SERVICE BULLETIN

May 27, 1999

SAFETY RECALL CODE 0812 - 1999 X1 REAR BRAKE LINE AND POSITIVE BATTERY CABLE

B-020

Figure 1. Rear Brake Line - Right Side

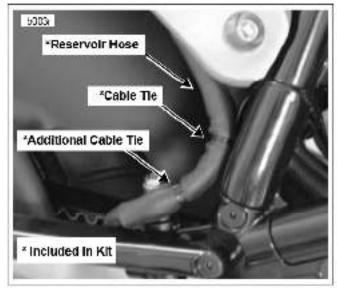
- See Figure 1. Cut cable tie holding rear brake reservoir hose to rear brake line above rear master cylinder on right side of motorcycle.
- See Figure 4. Disconnect two wires from rear brake light switch.
- Remove rear master cylinder banjo bolt and two banjo washers. Discard banjo washers.
- Remove rear brake caliper banjo bolt and two banjo washers. Discard banjo washers.
- Carefully push up on bottom of oil tank to allow rear brake line tangs to be freed from stude on the bottom of the oil tank.
- See Figure 2. Cut cable tie on wiring harness and cable tie on vent tube on left side of bike.
- Slide rear brake line into area where battery usually sits and then off of bike through left side of frame.
- See Figure 4. Remove rear brake light switch from original brake line.

- See Figure 1. Inspect rear brake reservoir hose on right side of motorcycle for damage. Replace as required by Installing new replacement hose provided in kit. If hose is undamaged, proceed to step 23.

- See Figure 1. Install two cable ties (thick) to reservoir
 hose and rear brake line in two locations as shown in figure. Use care to avoid pinching hose.

Figure 2. Rear Brake Line - Left Side

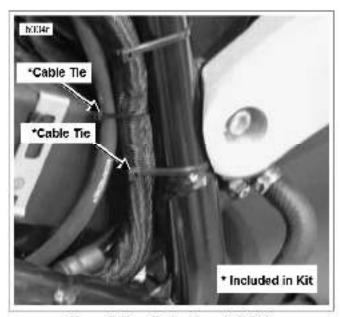
- See Figure 6. Inspect positive battery cable and vent lines (transmission vent and cam cover vent) for damage. Replace as required.
- 26. See Figure 2. Cable tie vent hose and wire harness to frame on left side of motorcycle. NOTE: Use thick cable tie on wire harness and thin cable tie on vent hose. Use care to avoid pinching hose.

Figure 4. Rear Brake Light Switch

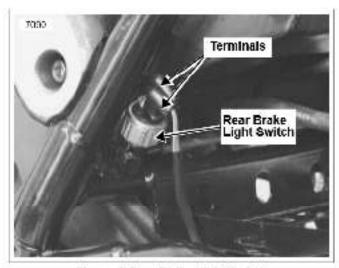
- Attach oxygen sensor connector to battery strap with new thin cable tie on left hand side of motorcycle.
- See Figure 4. Connect rear brake light switch wires to rear brake light switch.

Figure 6. Positive Battery Cable Routing

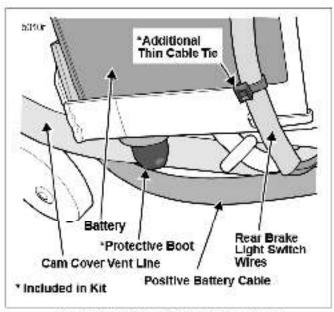
- See Figure 6. Install protective boot, included in kit, over stud and nut on bottom of battery tray on right hand side of motorcycle.
- Install bettery with strep and nut. Tighten nut to 40 in-lbs. (4.5 Nm)

- 36. See Figure 6. Attach rear brake light switch wires to bettery strap with new thin cable tie on right hand side of motorcycle. NOTE: HDI (all except Canada, Japan and New Zealand) models do not require this cable tie as the brake light switch wire routing is different.

Figure 7. Transmission Vent Line Routing (Rear View)

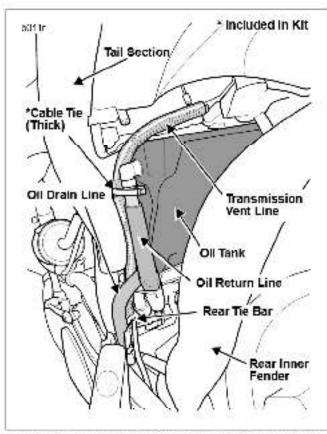
- 28. See Figure 7. Renoute transmission vent line to left side of motorcycle, under battery tray, over rear tie bar, above rear brake line, between oil drain line and tail section, above oil return fitting (on oil tank), and over the top of the oil tank. Use care to avoid kinking hose after tie bar.

- See Figure 7. Attach transmission vent line to oil return line as shown with new (thick) cable tie.
- See Figure 8. Reroute positive battery cable from starter solenoid post under rear brake light switch wires and under cam cover vent line then behind and over battery to positive terminal.
